IGP TAP Transmission Subgroup

Feedback on UFLS Study Plans

3/8/2022

This feedback to HECO is based on HECO's slides and presentations on 2/25/2022 related to their initial plans for a UFLS study.

Proposed Scope

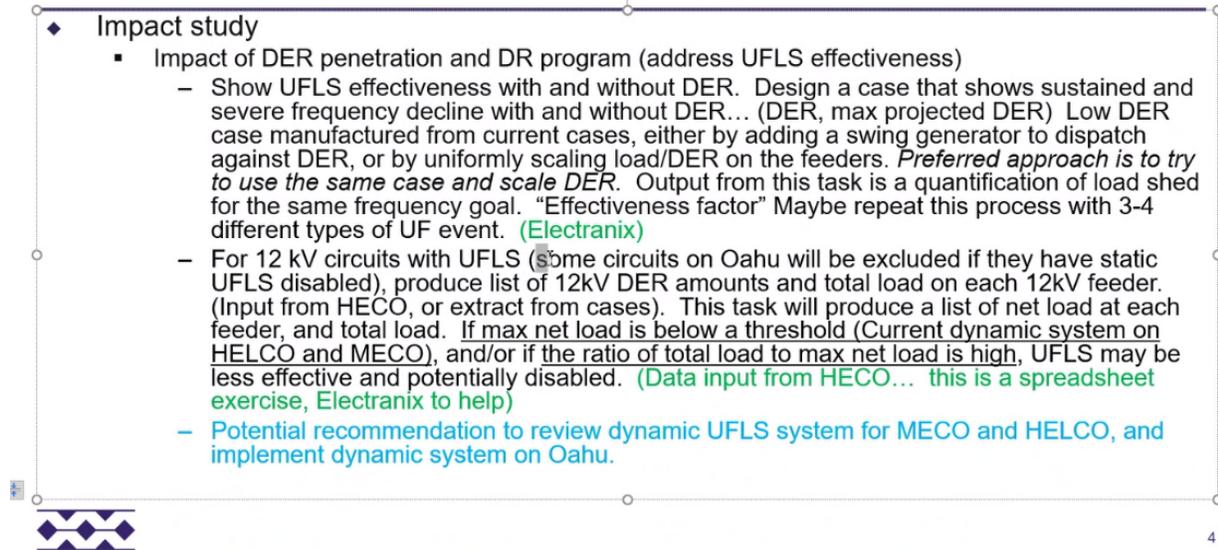
The first bullet on the slide below may not be needed if existing studies already examined this and are still relevant (or it may only be needed for some islands). In addition, the TAP recommends a broader

study scope in line with the various red recommendations in this document, to the extent possible in the time allowed.

PSCAD simulations can be one aspect of this study but are not necessarily the focus of the study.
